Title: LIGHTING FIXTURE FRAME AND MOUNTING PANEL APPARATUS  
 Filed: 7-31-2003 Inventor: Shin W. Rhee  
 Practitioner's Docket No.: THINL.64349

ANNOTATED SHEET SHOWING CHANGES

### **AMENDMENTS TO THE DRAWINGS:**

**FIG. 12**

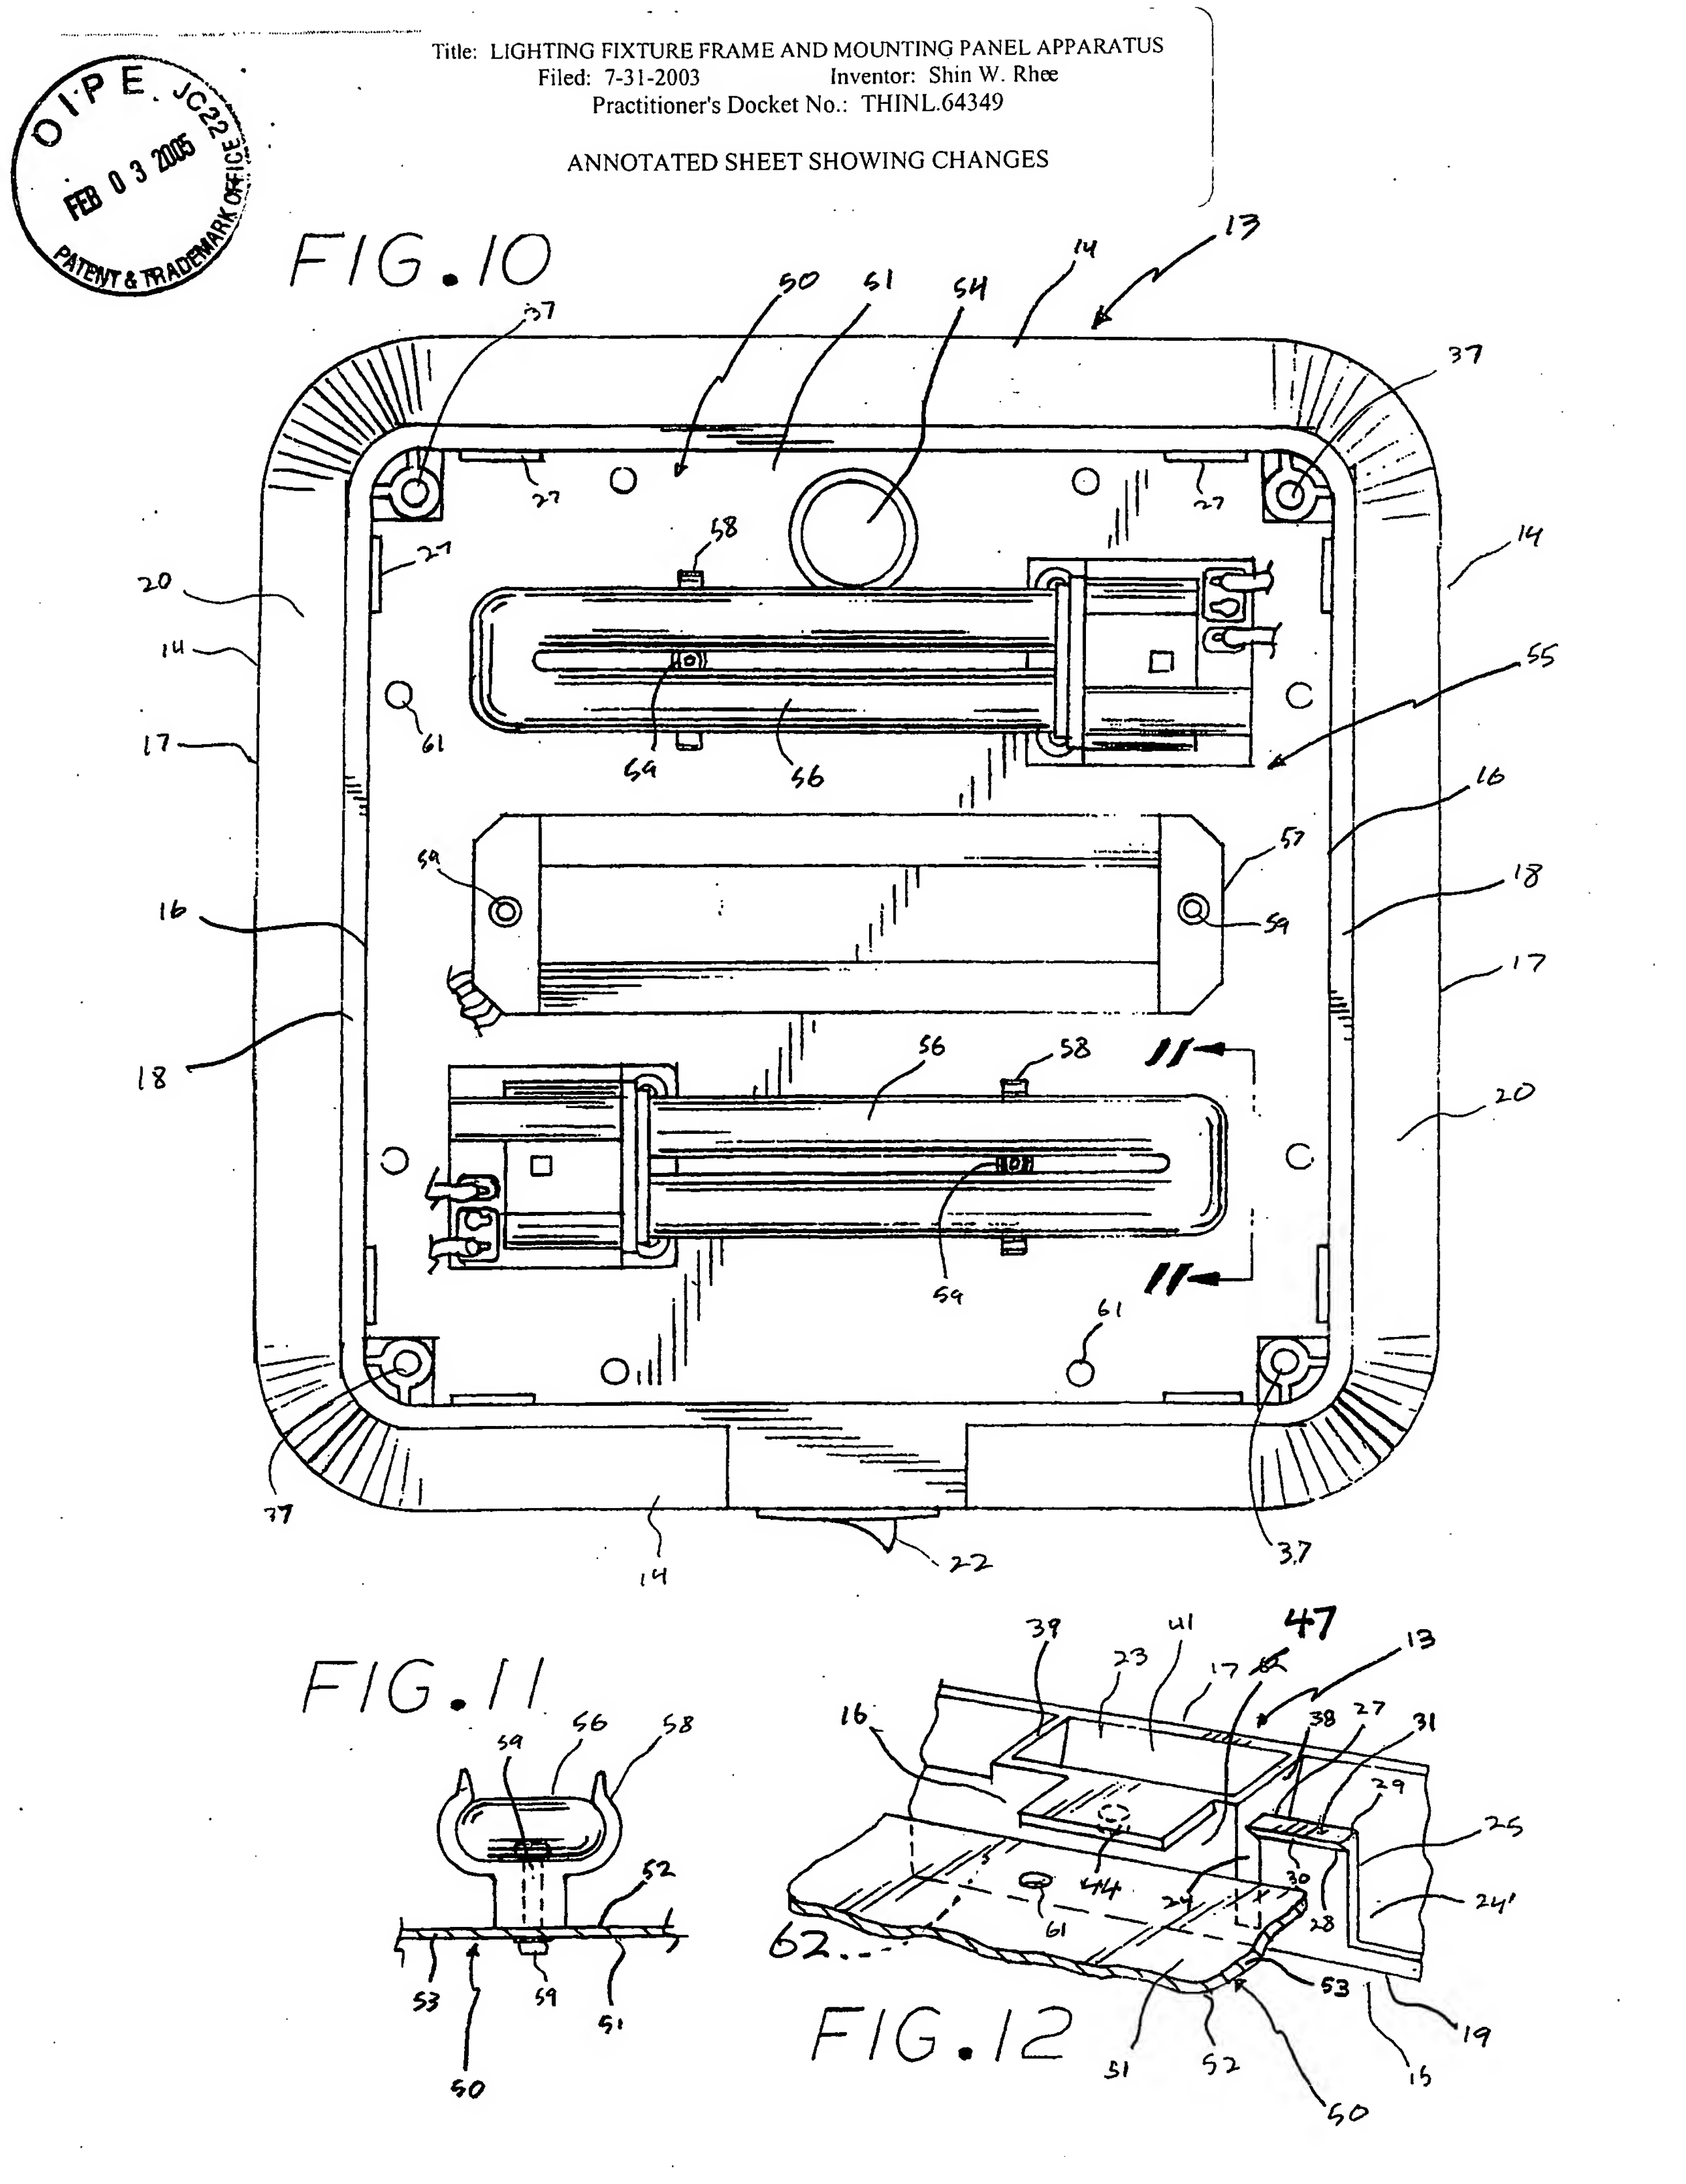
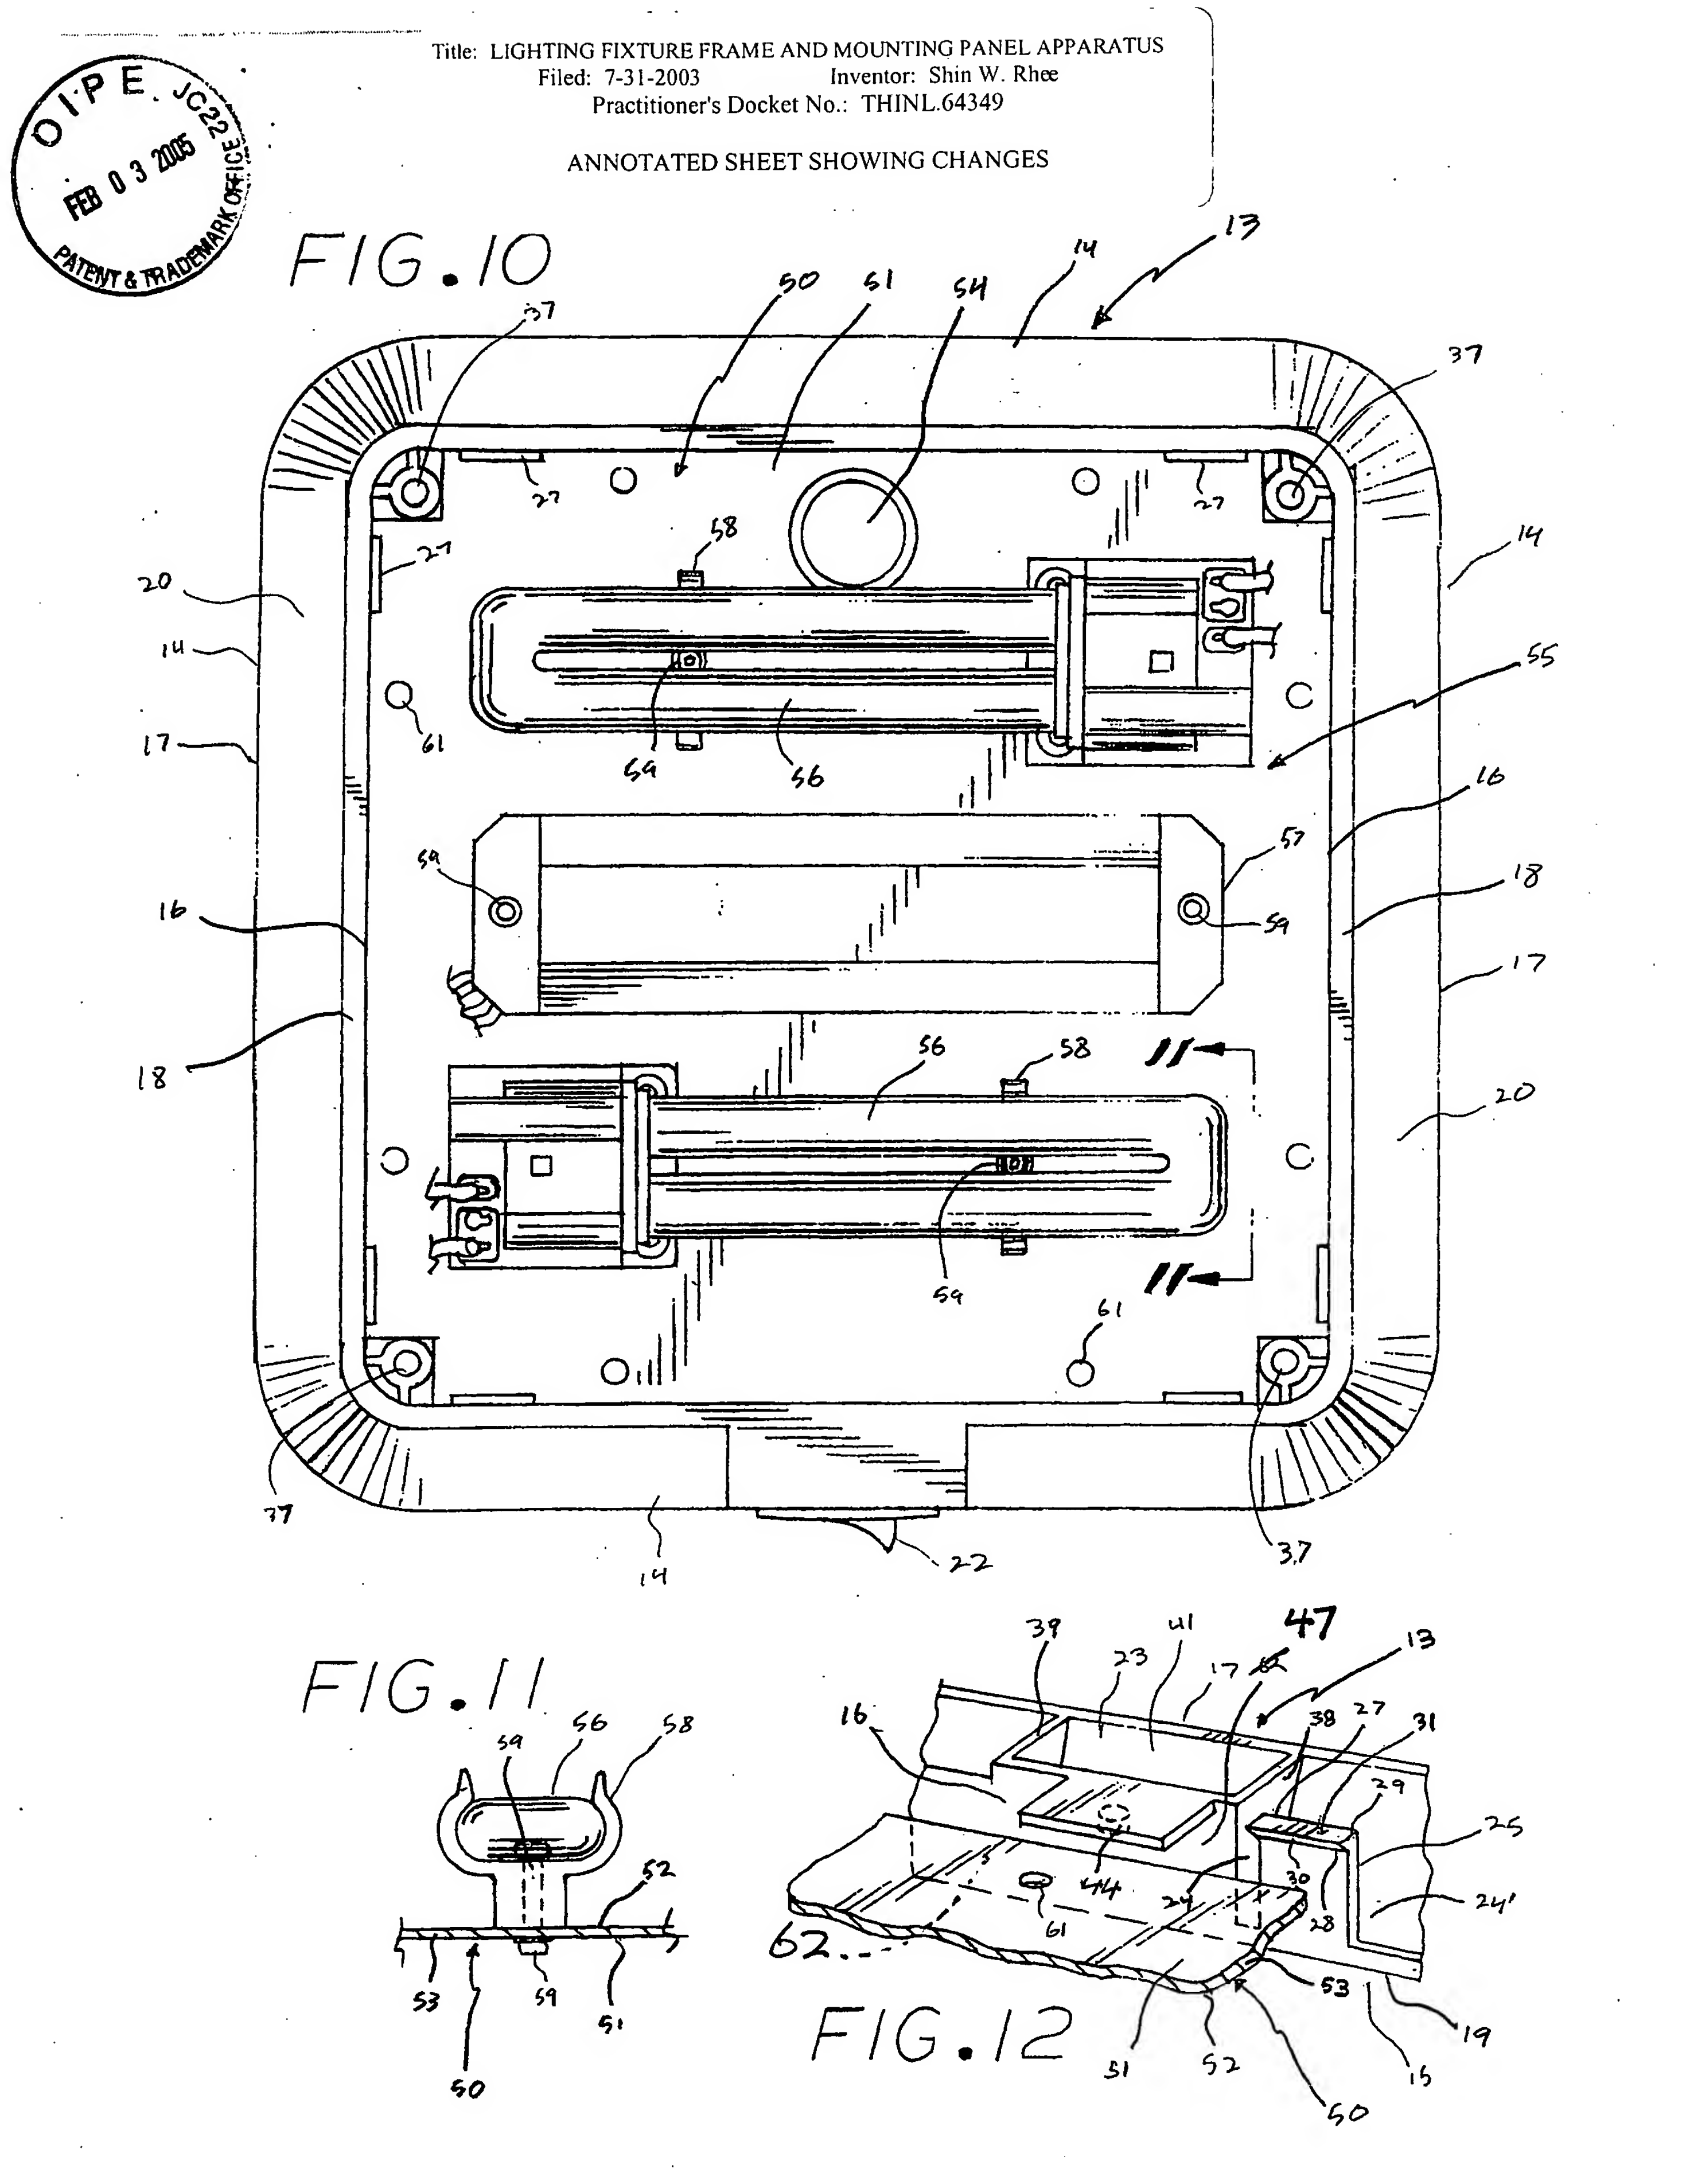
In the subject Office Action, the Examiner has also objected to the drawings. Specifically, the Examiner's detailed review of Applicant's drawings revealed that they failed to include reference element number 47, as referred to in the written description, and also failed to show a reference element number for certain features recited in the claims.

In the formal drawings which Applicant has filed concurrently herewith, and in the Replacement Sheet and Annotated Sheet Showing Changes included as an exhibit to this document, Applicant has correctly depicted reference element number 47 in Figure 12 of Sheet 4 of 4. Also, reference element number 62 has been redrawn. Consideration of these revisions should remove this objection.

The attached replacement sheet of drawings (sheet 4 of 4 as originally filed) includes changes to Fig. 12. This sheet, which includes Figs. 10-12, replaces the original sheet including Figs. 10-12. In Fig. 12, previously mislabeled element 62 has been changed to element number 47, and a new depiction of element number 62 has been added.
